Project	IEEE 802.16 Broadband Wireless Access Working Group < http://ieee802.org/16 >	
Title	Restructuring and Renaming of Management Primitives in section 14.2.9	
Date Submitted	2006-0405-3003	
Source(s)	Jaesun Cha	jscha@etri.re.kr
	ETRI	
	Ronal Mao	rmao@huawei.com
	Huawei Technologies Co., Ltd.	
	Ronny (Yong-Ho) Kim	ronnykim@lge.com
	LG Electronics, Inc.	
Re:	Contribution on comments to IEEE 802.16g/D2	
Abstract	In this contribution, we propose to define some primitives for Neighbor BS Management.	
Purpose	Adoption	
Notice	This document has been prepared to assist IEEE 802.16. It is offered as a basis for discussion and is not binding on the contributing individual(s) or organization(s). The material in this document is subject to change in form and content after further study. The contributor(s) reserve(s) the right to add, amend or withdraw material contained herein.	
Release	The contributor grants a free, irrevocable license to the IEEE to incorporate text contained in this contribution, and any modifications thereof, in the creation of an IEEE Standards publication; to copyright in the IEEE's name any IEEE Standards publication even though it may include portions of this cont

Figure 505—The use of primitives to generate MAC management messages

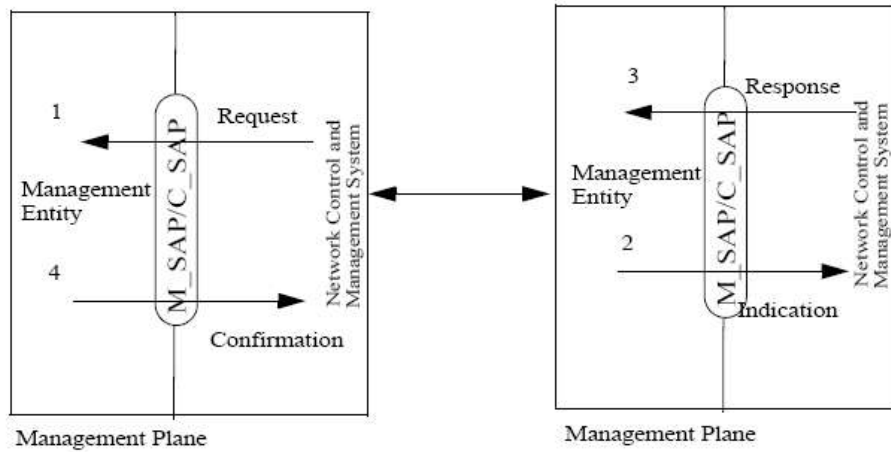
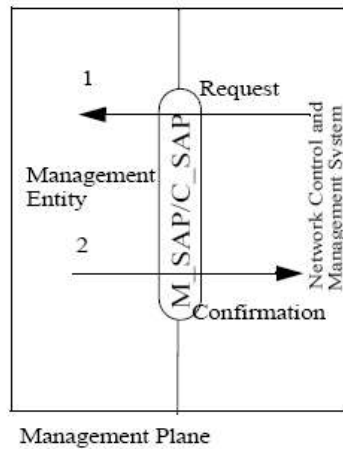
~~The IEEE 802.16 MAC shall support the following primitives which are delivered through C-SAP (Control Service Access Point) or M_SAP (Management Service Access Point) interfacing with NCMS (Network Control and Management System):~~

~~The use of these primitives to provide peer communication is shown in Figure 3. The use of primitive can be divided into two categories. The first category is with interaction with the peer entity, and the second category is primitive exchange within local stack.~~

~~Primitives exchange for the unidirectional MAC management messages, which don't require response messages, such as MOB_HOIND, MOB_TRF-IND, and for the local management of the MAC state machine, is shown in Fig. 3, (2). The initial request for service from a higher layer through NCMS is provided by the "Request" primitive. The request triggers either to generate appropriate unidirectional MAC management message or MAC state change depending on the primitive. "Confirmation" primitive conveying the result of the request is delivered to the higher layer through NCMS.~~

Figure 506 — The use of Ranging Primitives Figure 506a Ranging Primitives (MS Side)

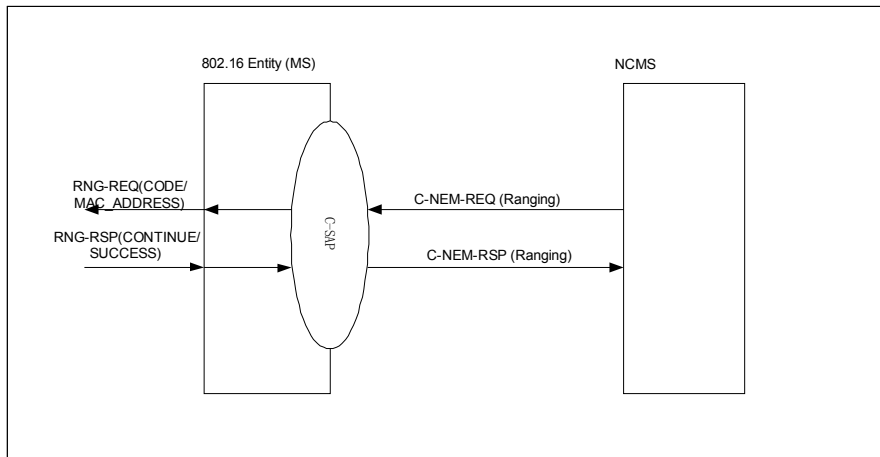
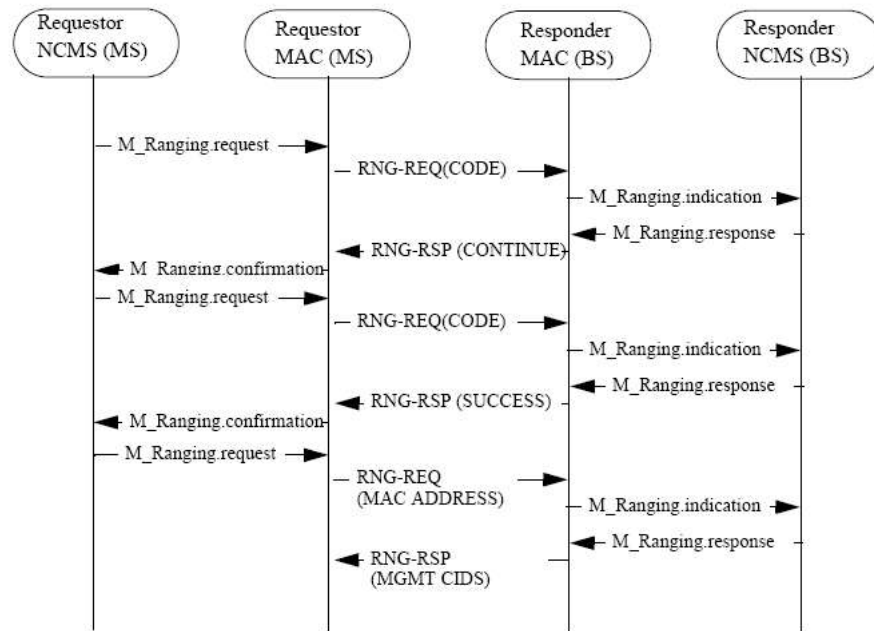
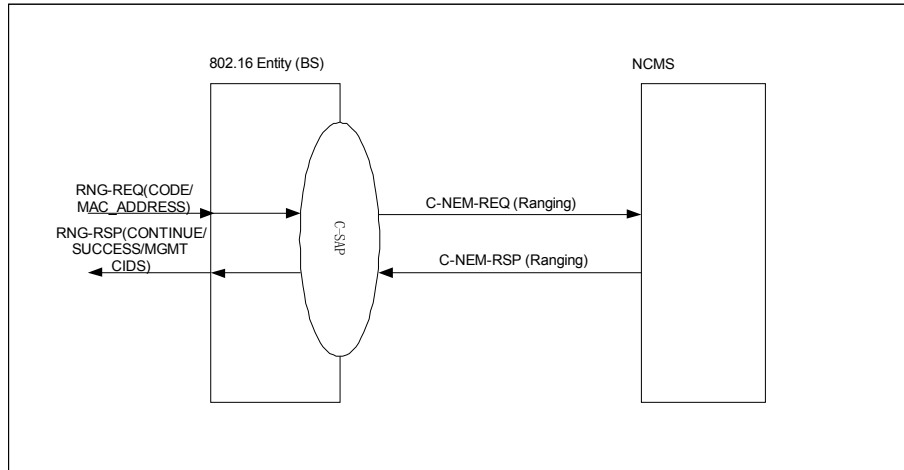
Upper layers can control ranging procedure with these primitives. Upper layers shall commence 802.16 link setup procedure by sending M_NEM-REQ(Ranging)M_Ranging-request primitive through NCMS.

Figure 506b Ranging Primitives (BS Side)

Figure 507 – The use of Registration Primitives [Figure 507a Registration Primitives \(MS Side\)](#)

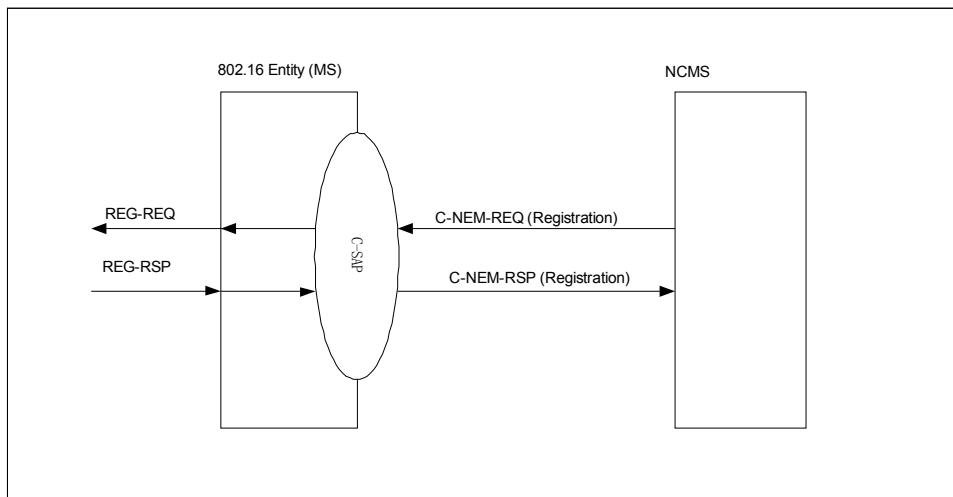
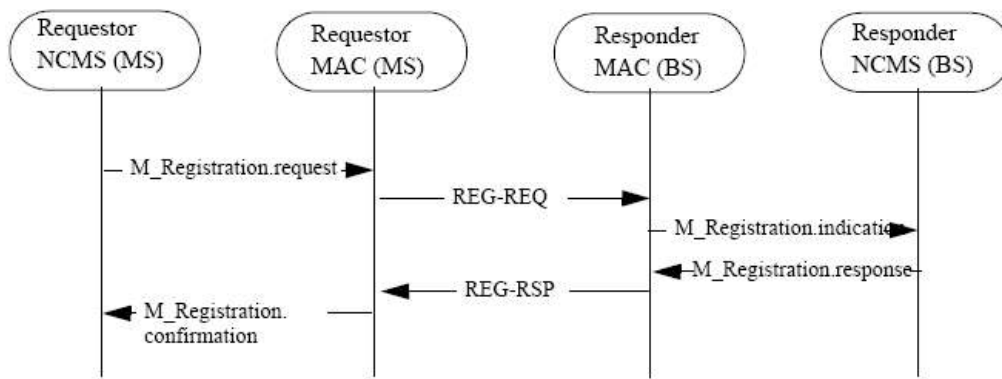
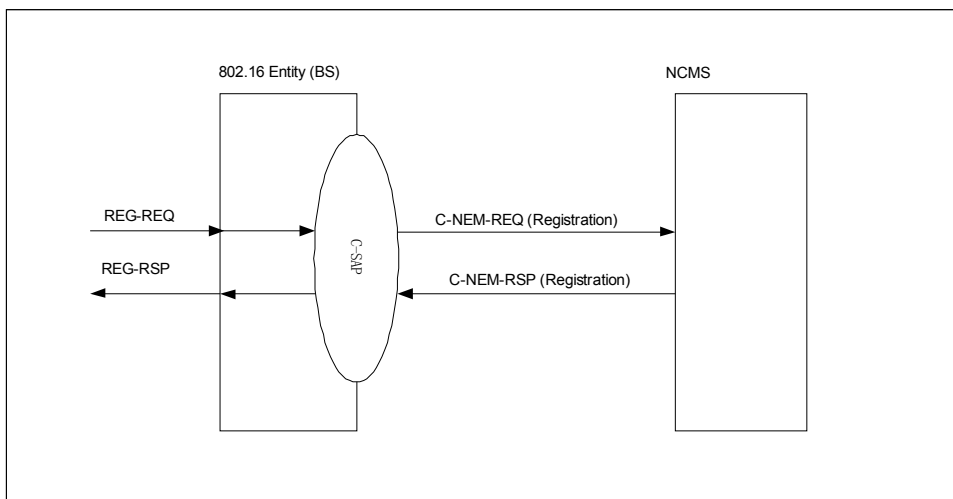
Upper layers can control registration procedure with these primitives. Upper layers are notified of link setup by M_Registration_confirmation: C-NEM-RSP/Registration.

Figure 507b Registration Primitives (BS Side)

Figure 508 – The use of Neighbor Advertisement Indication Neighbor Advertisement Primitives

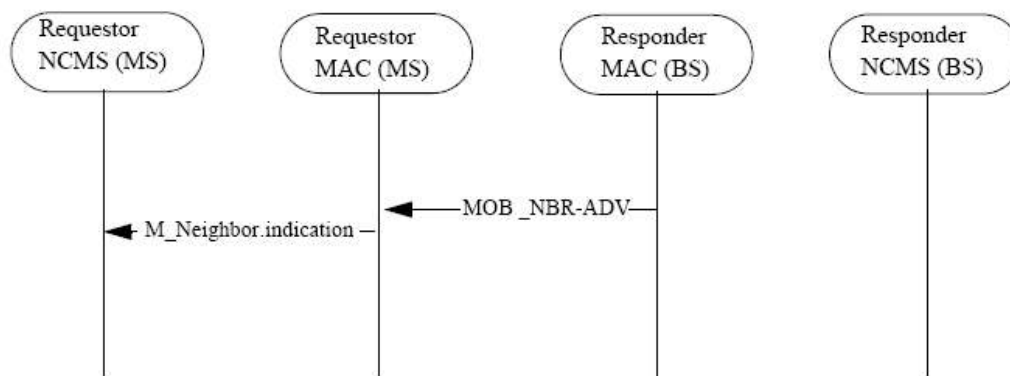
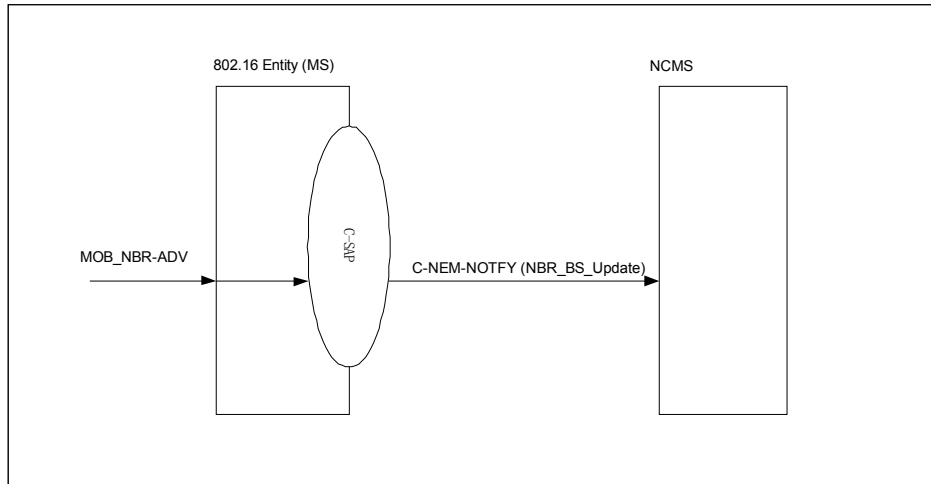
When 802.16 MAC receives neighbor advertisement (MOB_NBR-ADV), this primitive is used to deliver the information to upper layers.
